SERVICE BULLETIN

NUMBER: 06-001-12

Clutch Pedal Inoperative

Journey (International Only)

Fig. 1 Engine Compartment

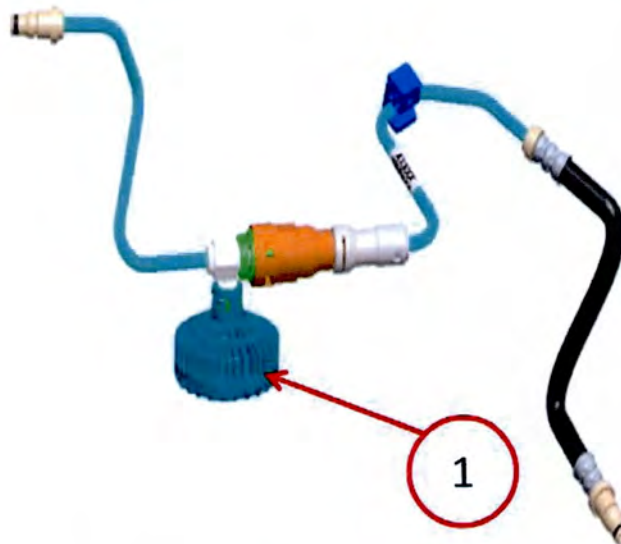
2. Stick your arm behind engine controller with an oil absorbing towel and place under damper (Fig. 1) and (Fig. 2).

Fig. 4 Clutch Damper

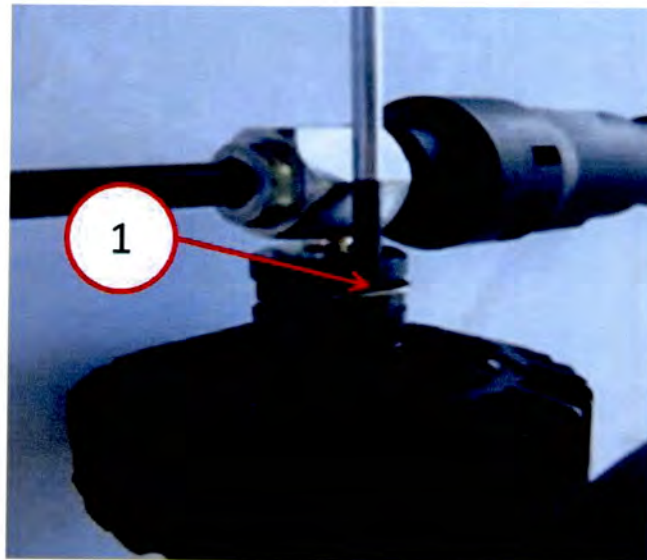
-
4. Rotate damper so you can see the damper retaining clip (Fig. 4).

1 - Damper Retaining Clip

Fig. 5 Clutch Damper

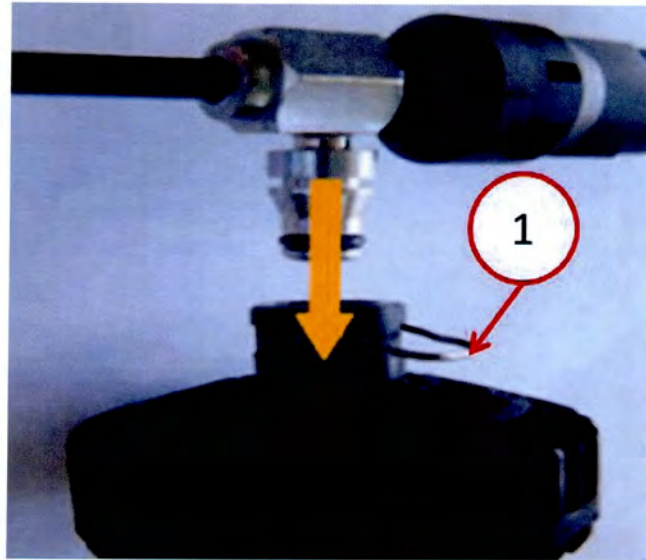
-
5. Pull the retaining clip out to the stop and remove the damper and discard (Fig. 4) and (Fig. 5).

1 - Clip Pulled Out

Fig. 6 Clutch Cap With Plug

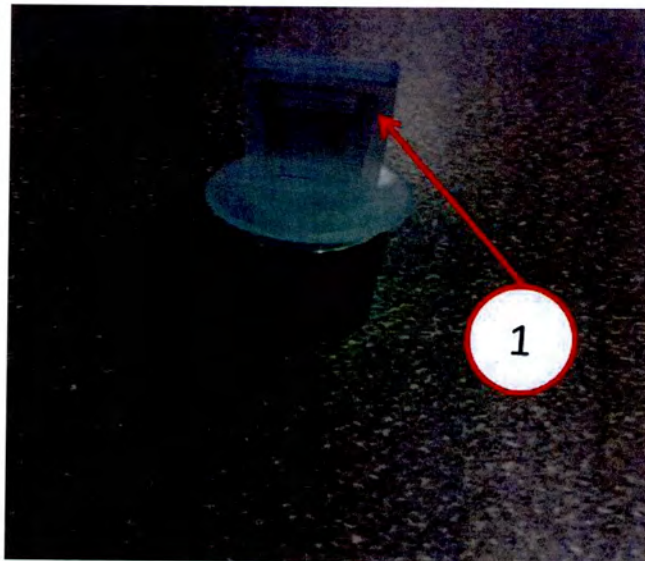
6. Remove dust plug from cap part number 68166291AA and discard (Fig. 6).

1 - Dust Plug

Fig. 7 Clutch Cap

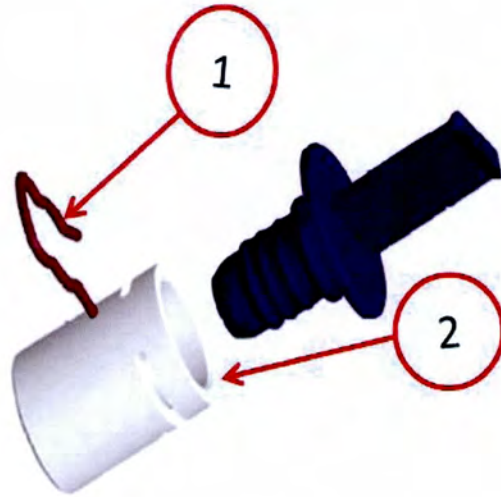
7. Install the retaining clip onto the new cap part number 68166291AA (Fig. 7).

- 1 - Clip
- 2 - Cap

Fig. 8 Hydraulic Line With Cap

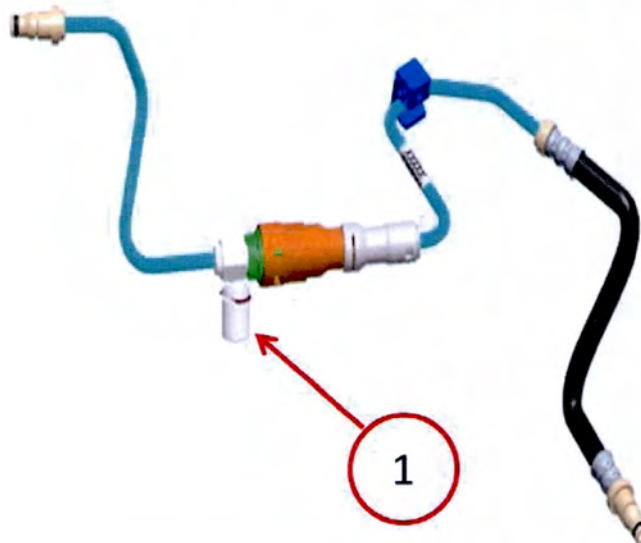
8. Install cap onto the hydraulic line in place of the damper (Fig. 8).

- 1 - Cap
-
